Project	**Energy Star Draft 2, Version 1-Convection Ovens**		
Subject:	Proposal of methodology for measuring energy consumption		
Written by:	Erika Menosso	Date:	08/04/2009
Contribution	Daniele Turrin		
Area:	Ecotech

Reference document: ENERGY STAR Program Requirements for commercial ovens. Draft 2: Eligibility Criteria

Figure D.1 – Position of the thermocouples

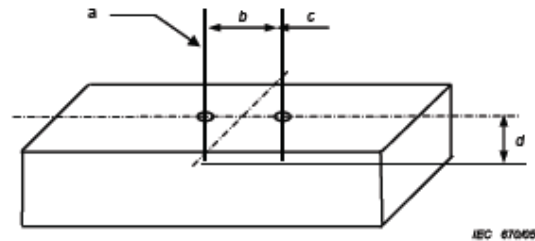
Proposal: instead a heavy load of potatoes, a inert, standardized material is used. The material could be Hipor, at disposal in bricks shape. Below, the specification of this kind of material, already used for household ovens performance in EU:

Electrolux proposal is to use this simulating food material instead vegetables, meat and so on, order to have the reproducibility of the test. Other conditions are:

- a single temperature sensor in the middle of the brick is enough,
- the oven load is performed with 3 brick for each pan
- the pan number is equal to the maximum loadable pans divided by 2
- before cooking test, the bricks are immersed in water (in order to increase their weight of 1 kg)
